AMENDMENTS TO COUNCIL COMMENTS/RESPONSE LETTER DATED 21.09.2015
ref. 671.1/2014

Project:
**1 VILLAWOOD PLACE
VILLAWOOD
NSW 2163**

DEVELOPMENT APPLICATION

Drawing Name:
**LANDSCAPE WORKS
ROOF TERRACE PLAN**

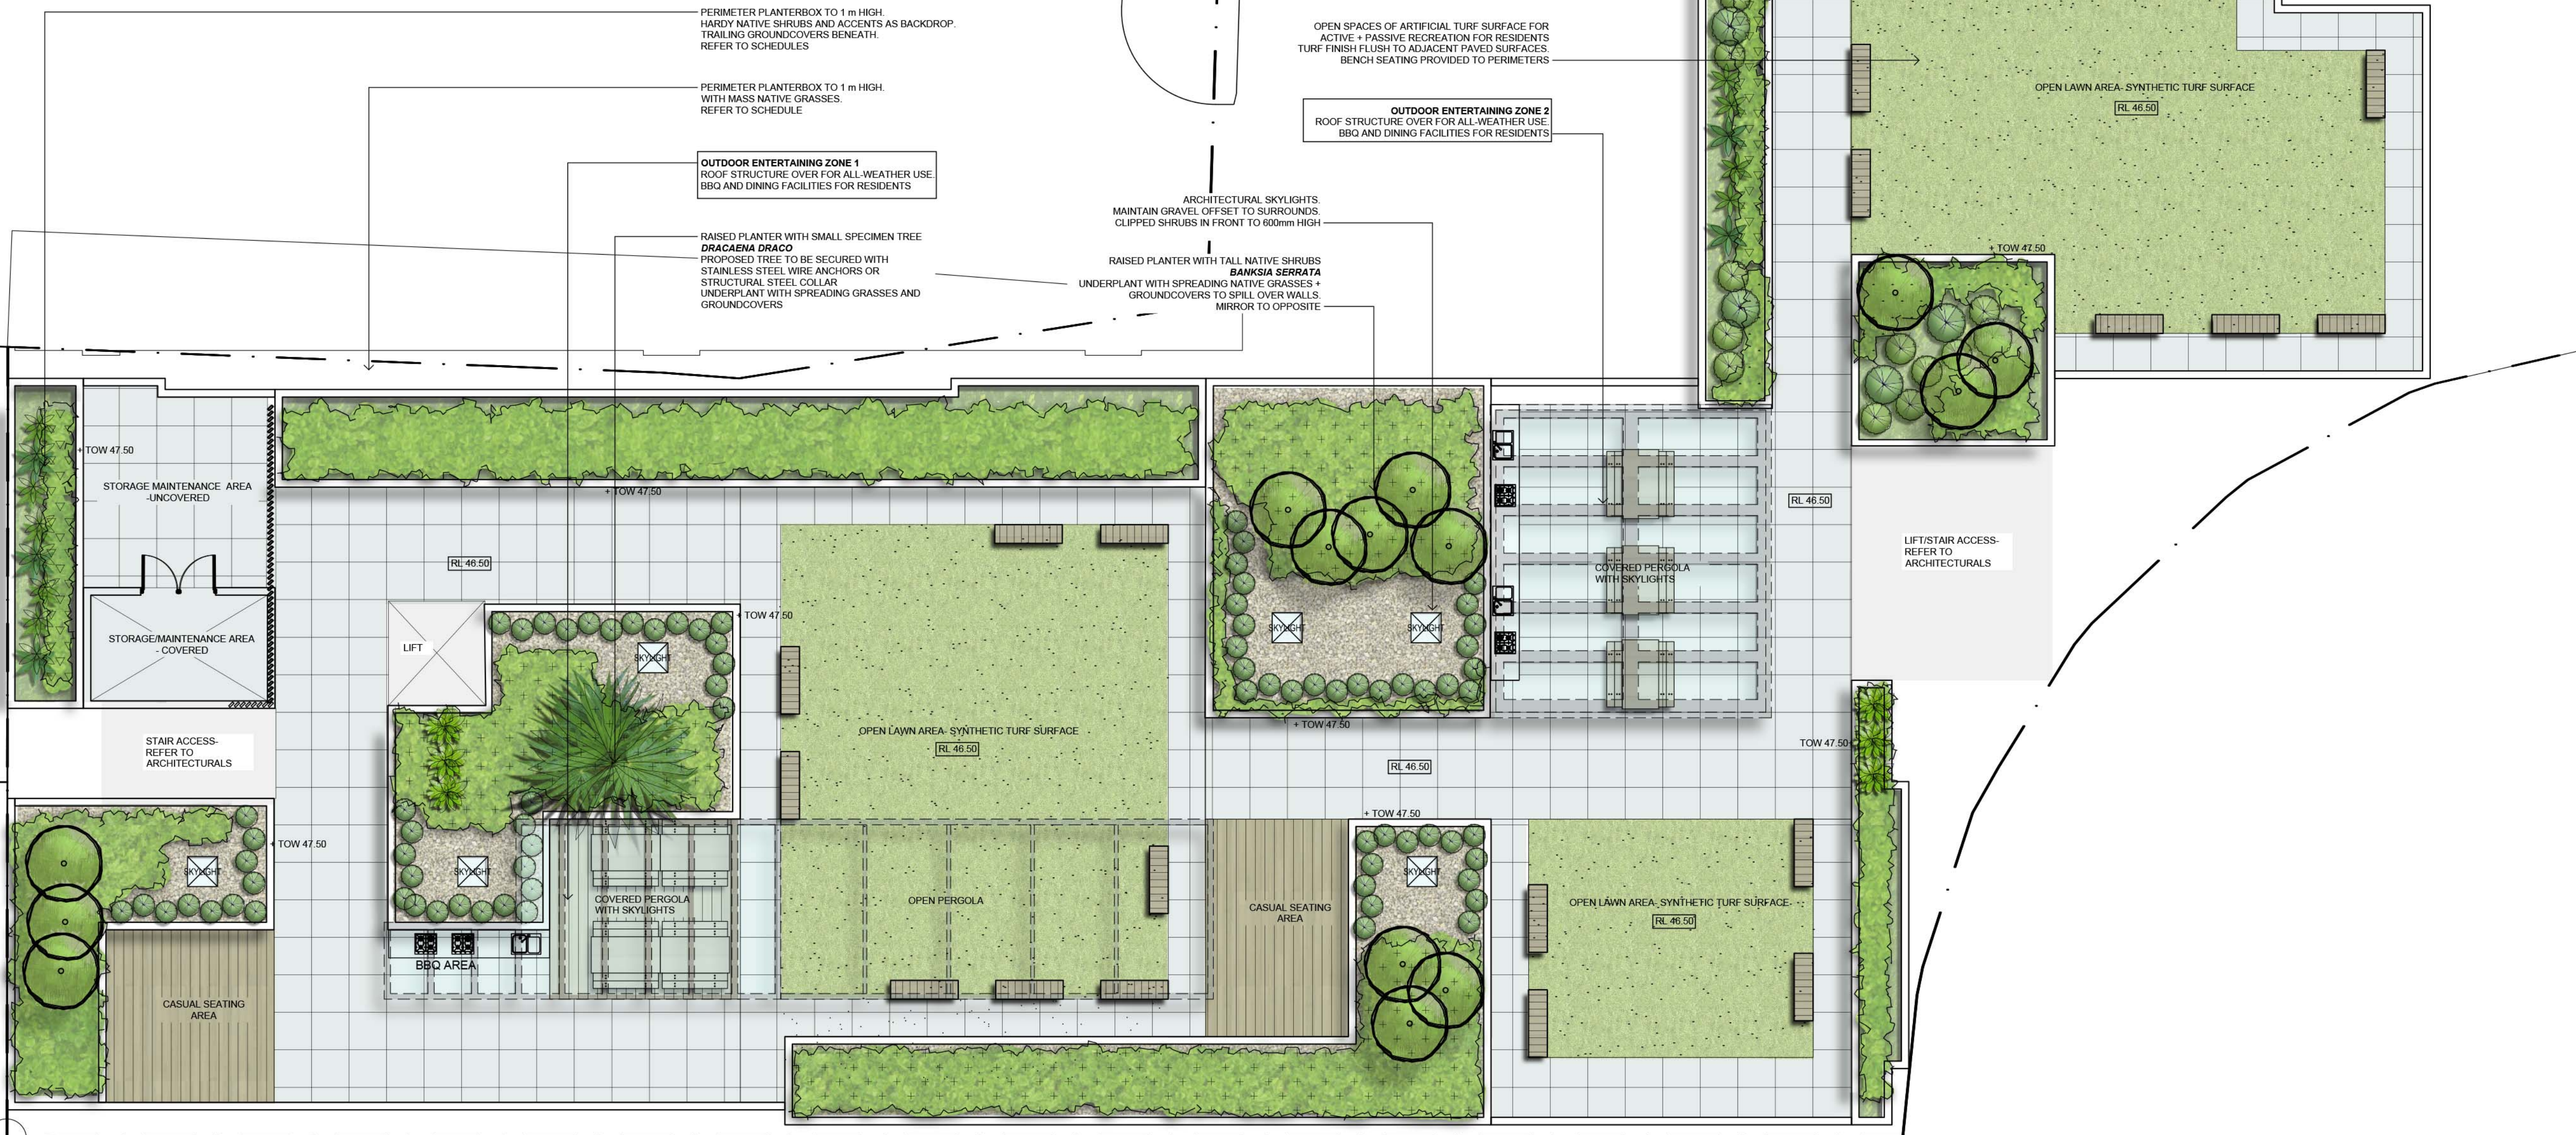
- SOUTH EASTERN PERGOLA SETBACK AMENDED TO 3M FROM BUILDING LINE TO REDUCE BULK AND SCALE
- NORTHERN PERGOLA SETBACK AMENDED TO 4M FROM BUILDING LINE TO REDUCE BULK AND SCALE
- CHANGE OF TREE SPECIES. REDUCE TO TALL SHRUBS. REFER TO LANDSCAPE RESPONSE LETTER
